From: Goodwin, Eoanna (REC)
Sent: Tuesday, June 24, 2025 9:32 AM
To: Zorana Bosnic; Ng, Beverly (REC); Roana Tirado; Brian Jencek; Aaron Fenton; Yonguk Kim; Laura Kerl; Amy Wu; Keating, Delaney (REC)
Cc: Ketcham, Dana (REC); Bradley, Stacy (REC); Rudnick, Kelli (REC); Bransten, Lisa (REC)
Subject: RE: Embarcadero Plaza - Project Delivery Meeting

Meeting in person at 49 South Van Ness Ave if you're available to review the Community Meeting 2 Slide Deck and discuss next steps.

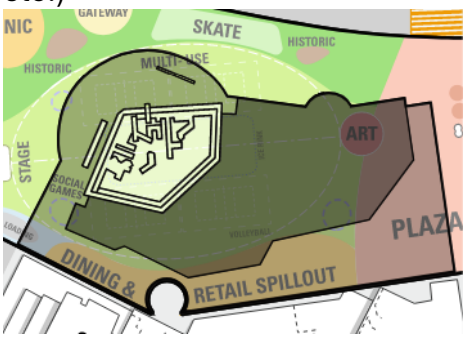
- (added fountain - slide 25): In addition to showing the fountain on sl. 22, add one more slide 24 “Park Program Diagram” with the fountain outline within the “multi-use” area, with the pump room and level change, like below, but no shade. List the “tradeoffs” on the right side (no stage/ events; no play fields; limited games/ fitness etc.)

Correct. Show the fountain/plaza within the space and how it would be designed restoring it. There are trade offs to both designs. The first no longer has the fountain, but there would be historic recognition area and all of the programmatic elements. The second would have the fountain but also the budget to restore takes away from many other elements in the park. The argument we've heard is that keeping the fountain could still meet our goals. I know you've already done the research on this, but the ask is to show it so we can have a productive conversation.
